ADMIRAL CHASSIS 3N1A, MODELS Y4049, Y4071, Y4072, Y4073

RUN 11 In All Sets

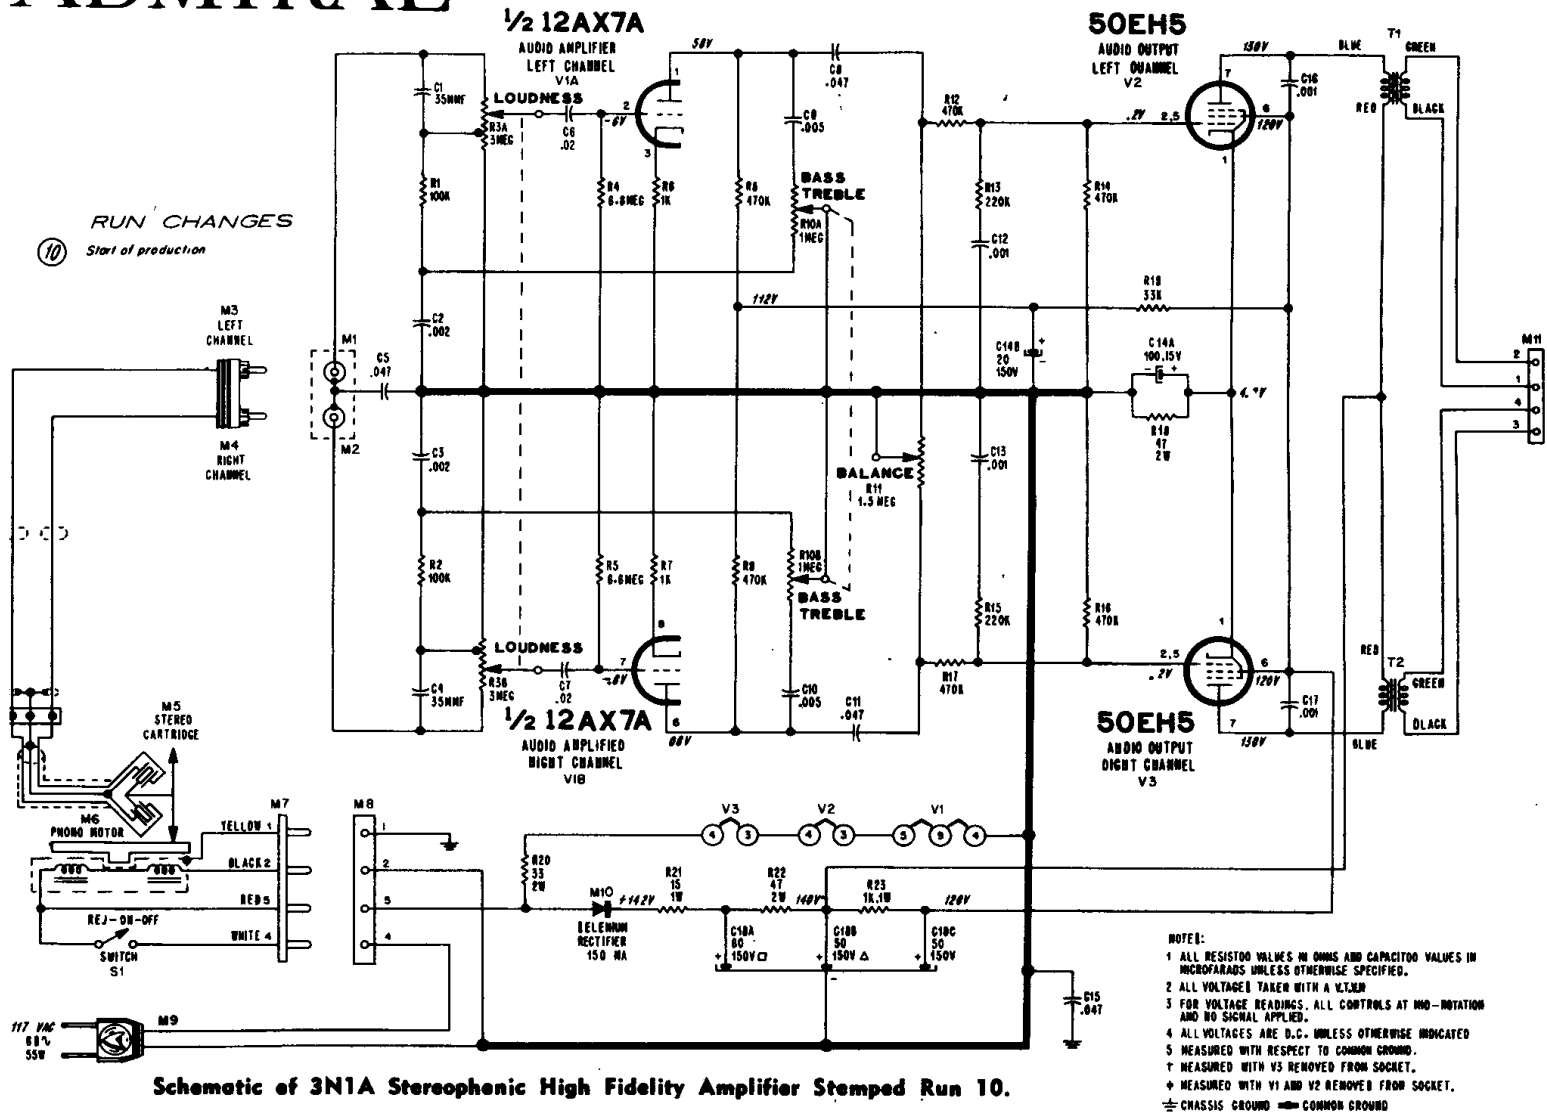
To improve performance (tonal quality) at low volume level, resistors R1 and R2 were changed from 100,000 ohms to one megohm, one-half-watt.
